March 20, 2018
15045

Third Party Review of the Rezoning Petition in Northern Aroostook County, Fish River Chain of Lakes Concept Plan

SLOPE EVALUATION OF FISH RIVER CHAIN OF LAKES DEVELOPMENT AREAS

LOCATION: CD-1	FOR: J.D. IRVING LIMITED	INFORMATION: 2011 LIDAR DERIVED DATA PROVIDED BY J.D. IRVING, LIMITED
-------------------	-----------------------------	--

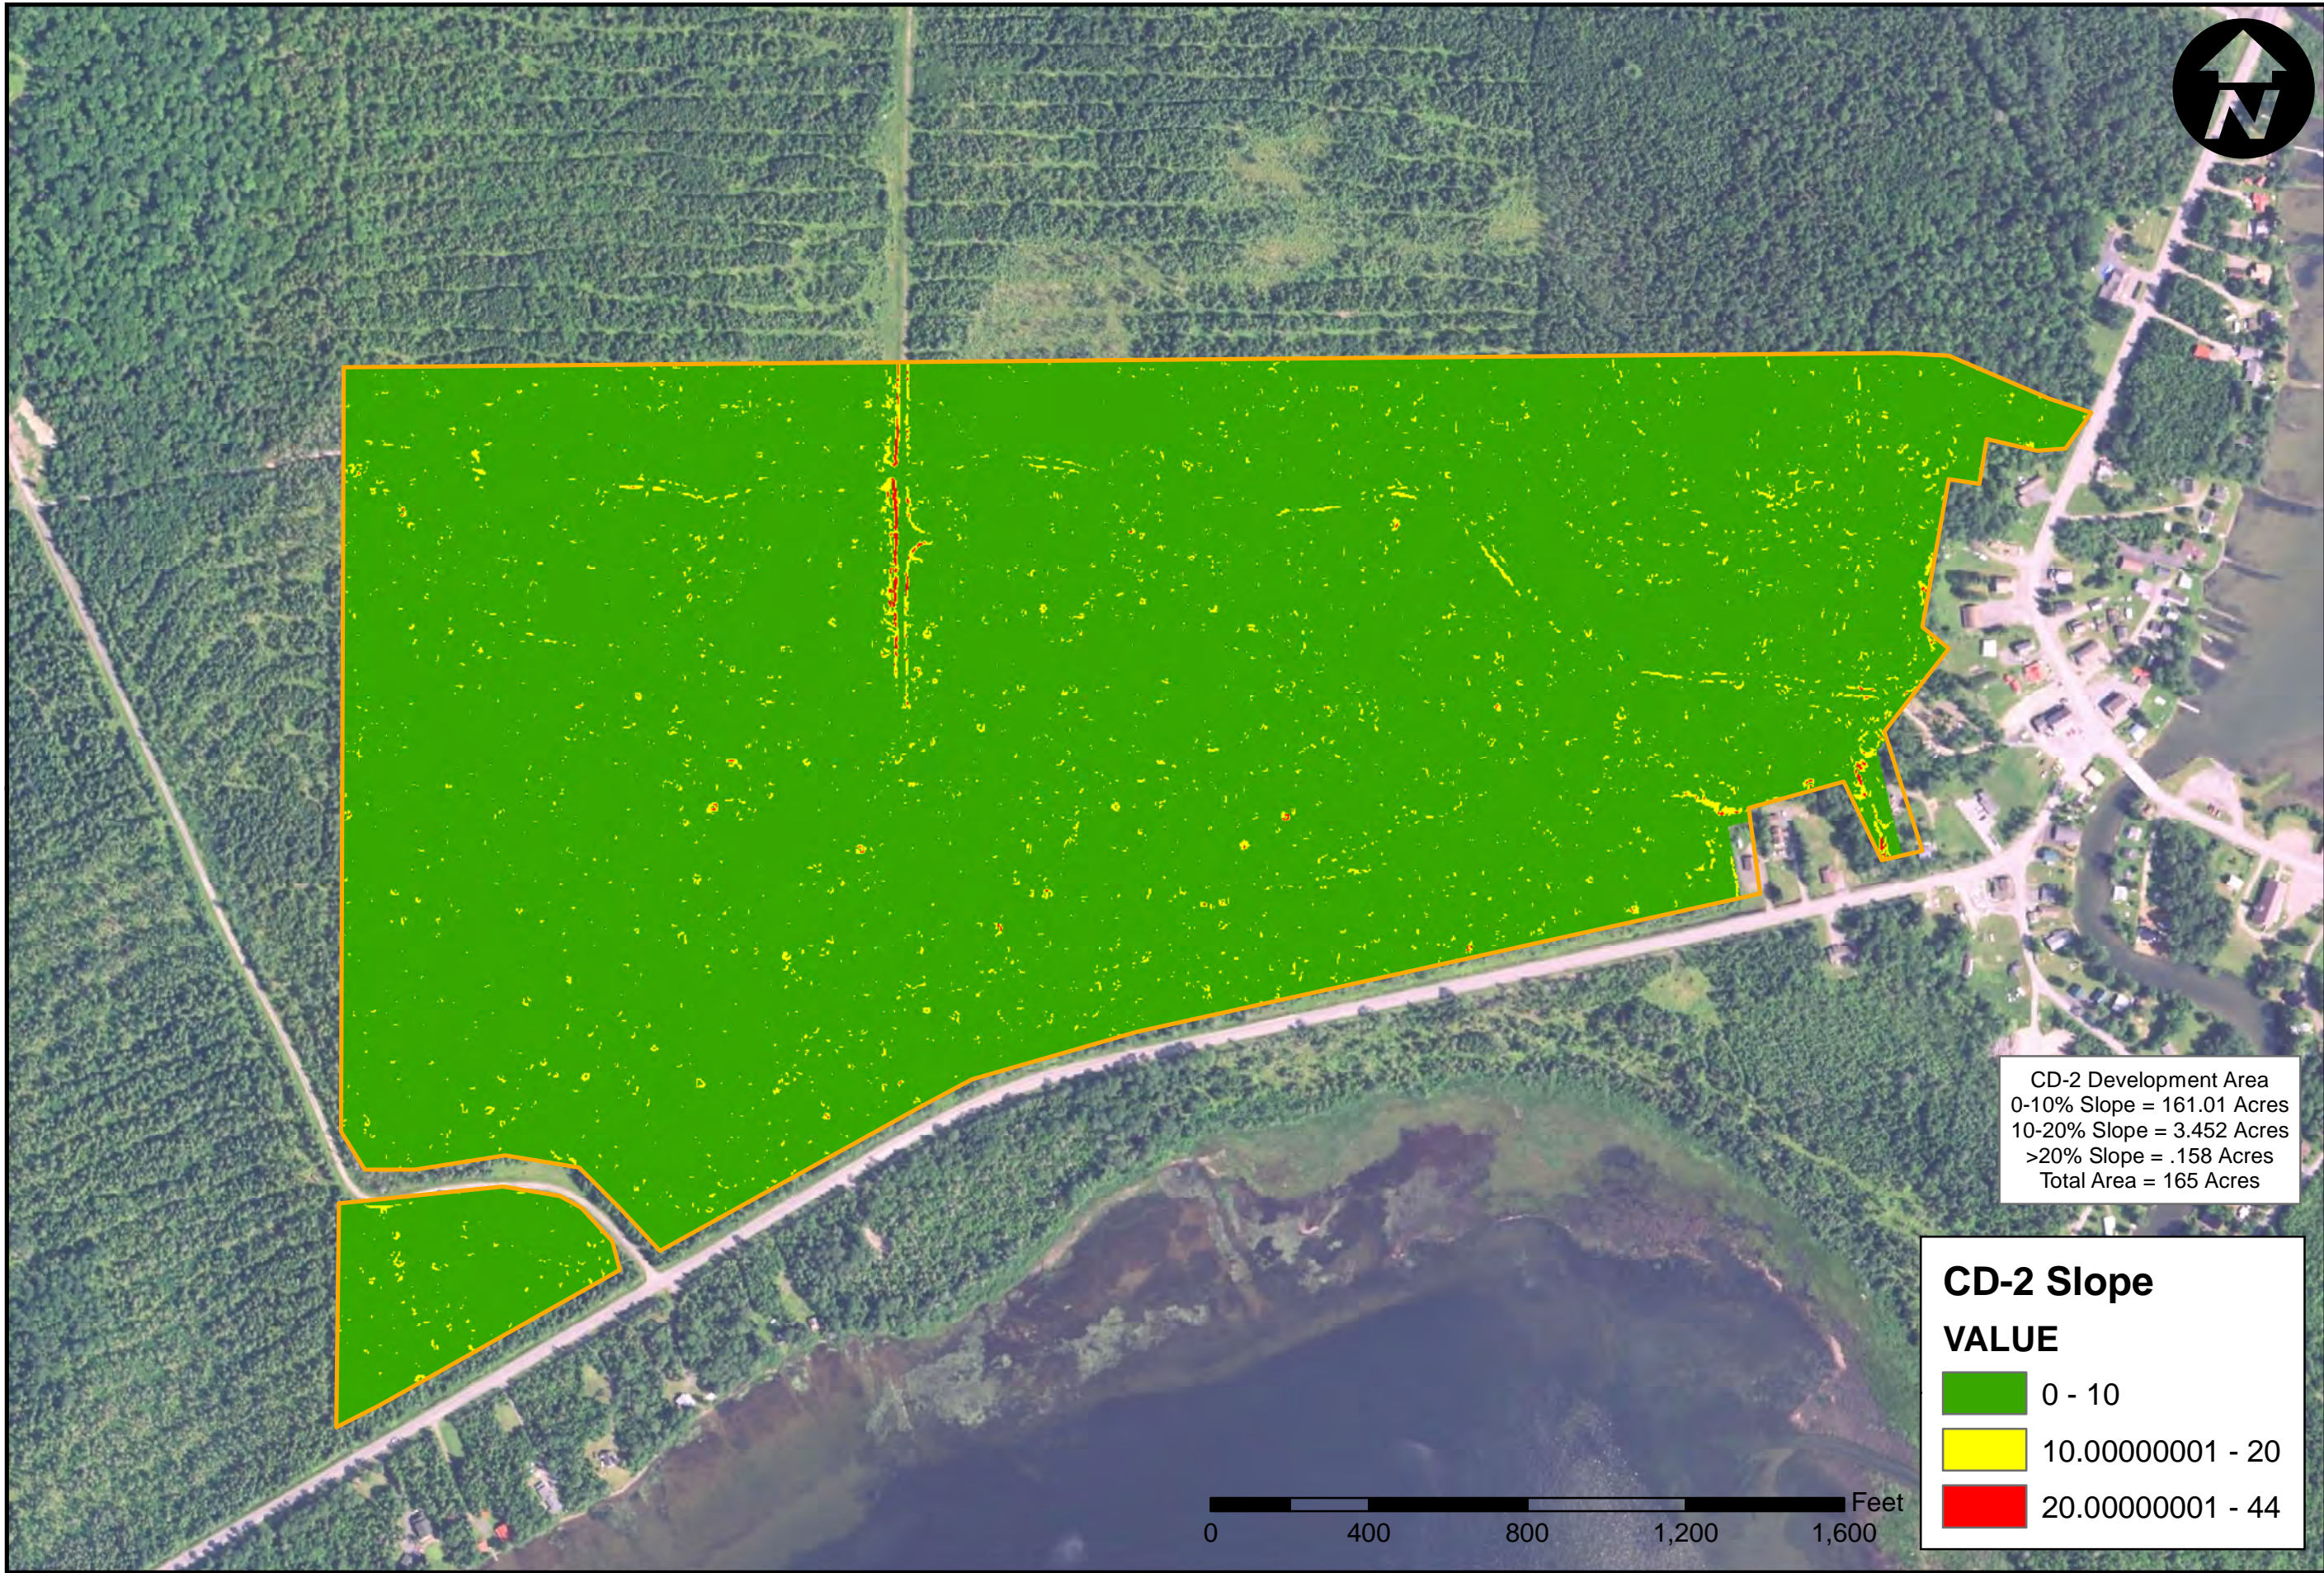
1. Slope Analysis: The slope analysis indicates approximately 1.6 acres of the development area contains slopes greater than 20 percent and are generally considered unsuitable for development. The greater than 20% slopes are few and likely associated with a random slope features. Slopes 0-10% slopes encompass approximately 262 acres. The limited suitability slopes (10 to 20% slopes) encompass approximately 18 acres of the project area. The slope assessment suggests the development area is suitable for the intended purposes noting that the few slopes greater than 20% are not considered suitable for development due to limitations for wastewater disposal systems, erosion and drainage control considerations and slope stability. These areas are very few and will have little or no influence on development.

2. The soils in this development area (NRCS Mapping) mapped as MoA (Monarda-Burnham complex), CdB (Canandaigua silt loam, thin solum), PvB (Plaisted Howland association)

soil series. The MoA and CdB soils are generally a silt-loam, poorly drained with a water table of 0" to 18" and include a hydrologic soil group "D" classification. These soils are indicative of potential wetlands and can be severely limited for subsurface wastewater disposal systems due to the depth to groundwater. Any development on these soils will require substantive engineering considerations for dewatering, subsurface wastewater disposal, higher erosion potential and potential difficulties addressing stormwater management.

The PvB soils are well drained with a water table depth of 26" or more and considered a hydrological group "C". These soils are generally suitable for development.

Since the CdB and MoA to the soil are prominent and located between the probably point of access and developable soils, we recommend field mapping of the wetlands and a site-specific soils survey to verify the soils, their limitation and the overall suitability of the parcel for development including means of access to the developable area. We understand some limited site-specific evaluations were completed but believe additional more specific work is required to assess the suitability of this land for development.

LOCATION: CD-3b/CD-3c/CD-4	FOR: J.D. IRVING LIMITED	INFORMATION: 2011 LIDAR DERIVED DATA PROVIDED BY J.D. IRVING, LIMITED	SCALE: 1" = 300'
			DATE: 03/07/18

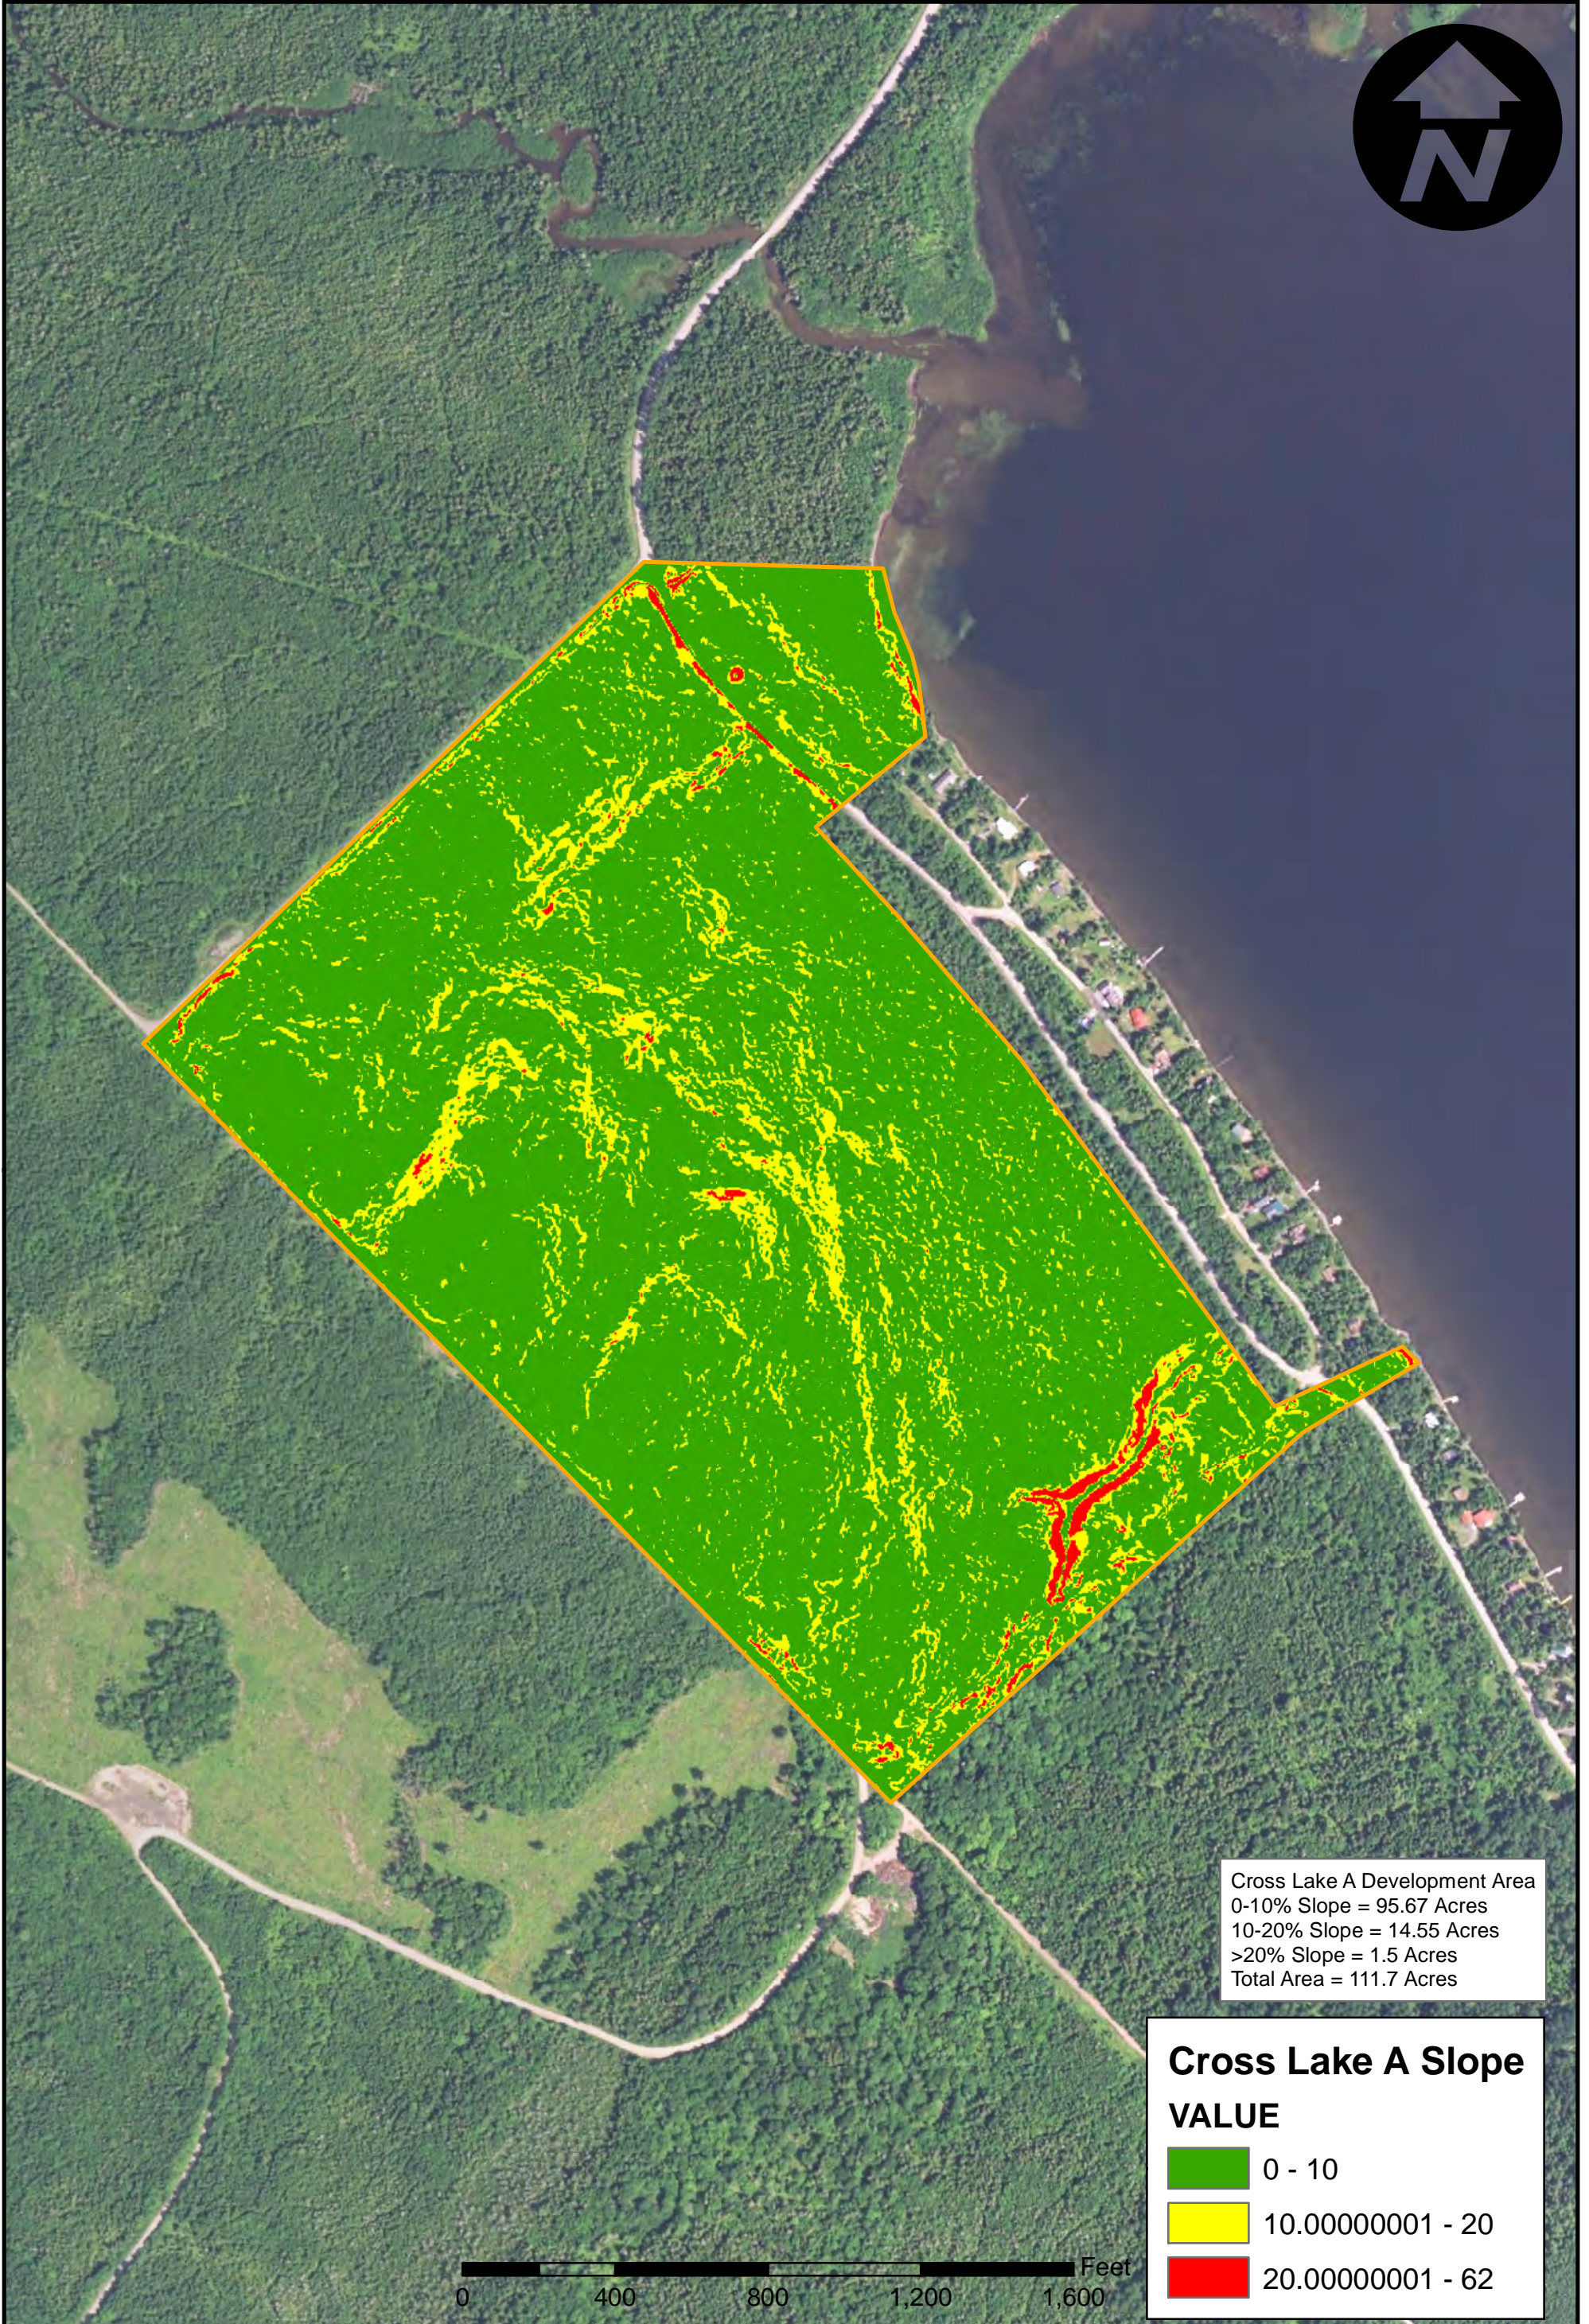
1. Slope Analysis: The slope analysis indicates the majority of the parcels contain slopes in the 0 to 10 percent range with only a very small component with slopes greater than 20%. Therefore, all four development areas are considered to have suitable slopes for development.

2. The soils in this development area (NRCS Mapping) are mapped as RaA (Red Hook and Atherton silt loams), and an area of MaB (Machias gravelly loam) soil series. The RaA soils are generally poorly drained and include a water table of 6" to 18" with hydrologic group B/D classification. These soils are indicative of potential wetlands and can be moderately limited for subsurface wastewater disposal systems due to the depth to groundwater. Any development on these soils will require substantive engineering considerations for dewatering, subsurface wastewater disposal, higher erosion potential and potential difficulties addressing stormwater management.

The MaB soils are moderately well drained with a water table depth of 18" or more and considered a hydrological group "B". These soils are generally suitable for development.

Since the RaA soils are prominent we recommend field mapping of the wetlands and a site-specific soils survey to verify the soils, their limitations and the overall suitability of the parcels for development. Given the peculiar shape of CD-3a and the narrow linear configuration of CD-3b these lots may be overly restrictive for development. We understand some limited site-specific evaluations were completed but believe additional more specific work is required to assess the suitability of this land for development.

LOCATION: CROSS LAKE C	FOR: J.D. IRVING LIMITED	INFORMATION: 2011 LIDAR DERIVED DATA PROVIDED BY J.D. IRVING, LIMITED
---------------------------	-----------------------------	--

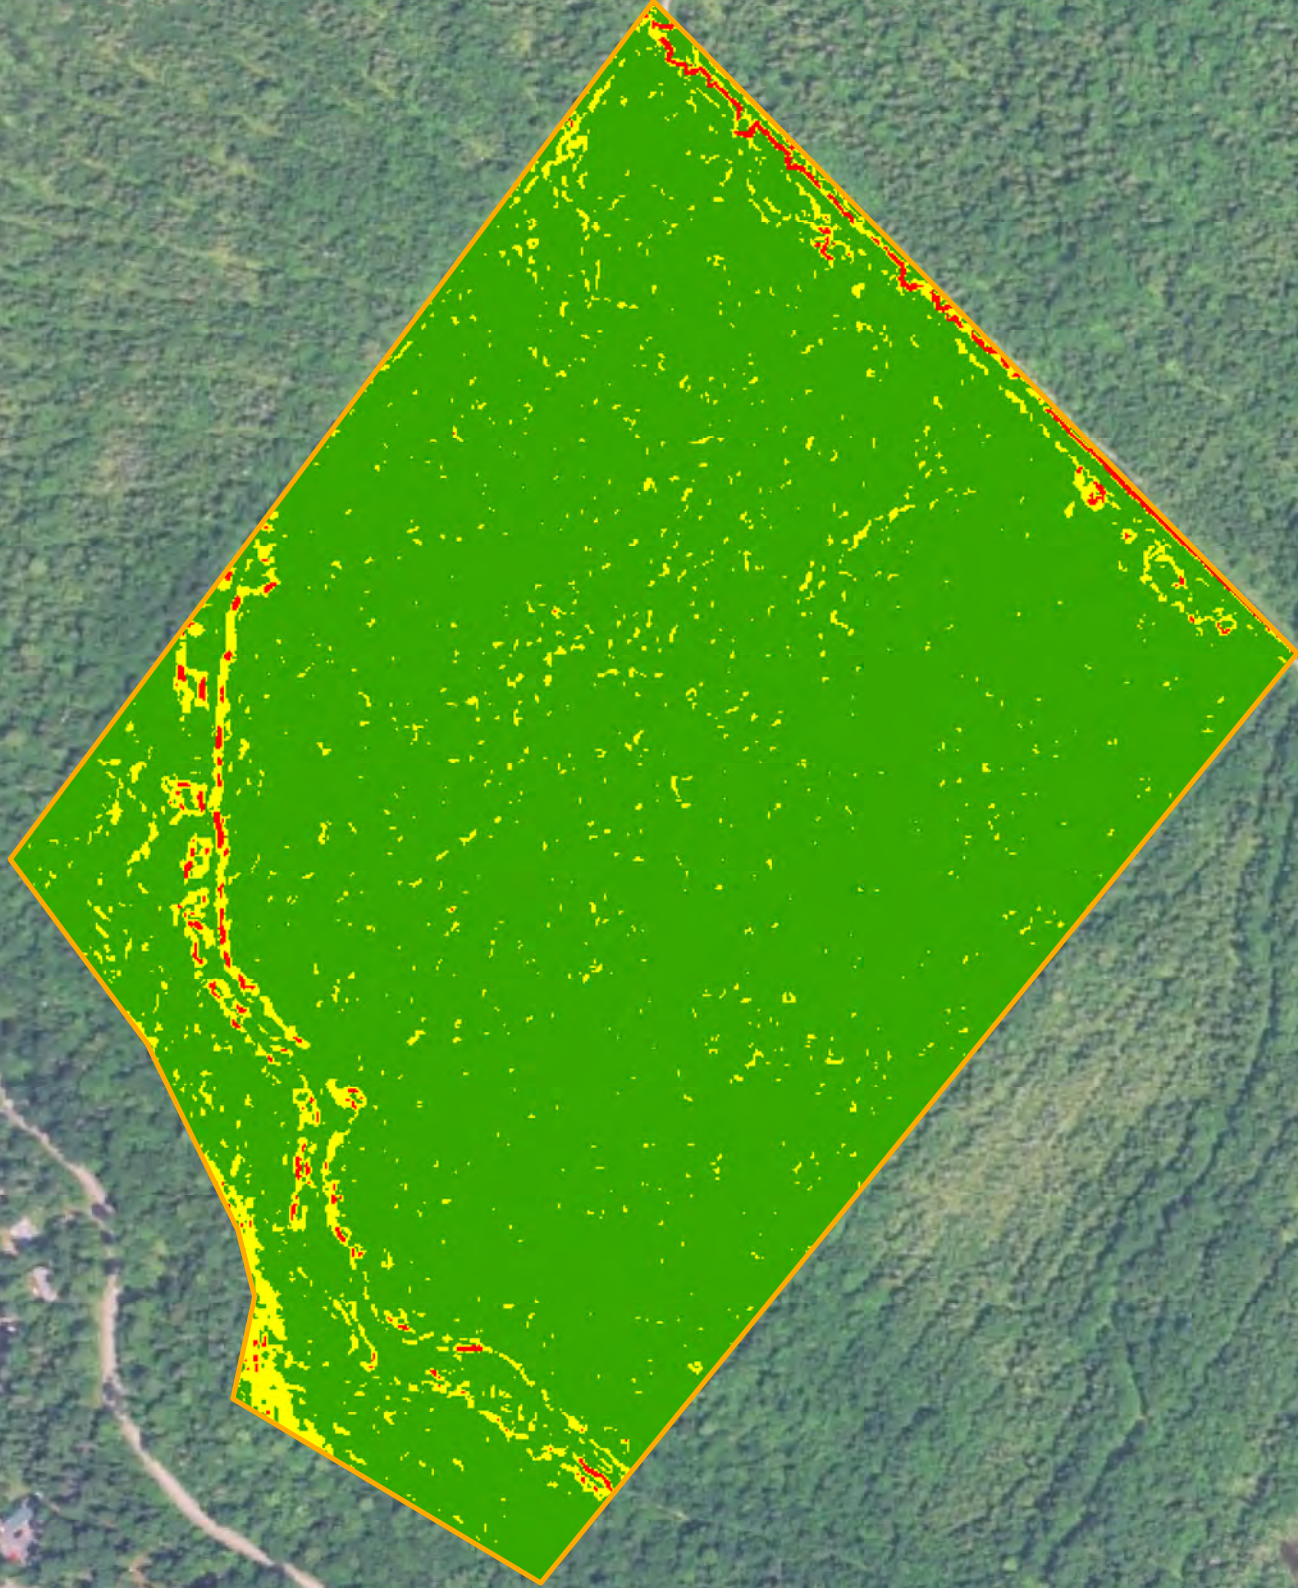
1. Slope Analysis: The slope analysis indicates approximately .44 acres of the development area contains slopes greater than 20 percent and are considered unsuitable for development. The greater than 20% slopes are few and likely associated with random slope features. Slopes 0-10% slopes encompass approximately 54.8 acres. Limited suitability slopes (10 to 20% slopes) encompass approximately 3.2 acres of the project area. The slope assessment suggests the development area is suitable for the intended purposes noting that the few slopes greater than 20% are not considered suitable for development due to limitations for wastewater disposal systems, erosion and drainage control considerations and slope stability. These areas are very few and will have little or no influence on development.

2. The soils in this development area (NRCS Mapping) include PgB (Plaisted gravelly loam) and MoB (Monarda-Burnham complex) soil series. The PgB soils generally gravelly loams and located on slopes 3% to 8%. These soils are generally well drained with a water table over 26 inches and considered a hydrologic group "C" soils. These soils types do not suggest any significant limitations for development beyond localized limitations as a result of a higher-grade soil mapping. The MoB soils are silt-loams, poorly drained and generally have a water table of 0 to 12." The MoB soils present severe limitation for septic systems and would require substantive engineering for dewatering and addressing erosion and stormwater management.

Considering the soils and associated development limitations our assessment suggests that the project area and number of planned units (30) yields an effective net density of .6 acres/unit. While the total land area would accommodate the LUPC dimensional requirements of 40,000 square feet per lot, the soil and slope restrictions allow for lessor net density of approximately 20,000 square feet of net developable area per lot. This represents a fairly compact development density (Please refer to the development matrix analysis appended to this report). This assessment includes deductions for slopes over 20% and allowing for 25% of the 10% to 20% (limited suitability slopes) to be considered not suitable.

The constraints of this site will require special attention to development planning, layout and the management of stormwater/erosion to meet Maine DEP chapter 500 regulations and may include nitrate studies with potential nitrate mitigation to protect both the lake and private drinking water wells.

In conclusion, we recommend further investigation of MoB mapped soil areas to verify the available development area and for the presence of restrictive soils impacting the planning, layout and configuration of development.
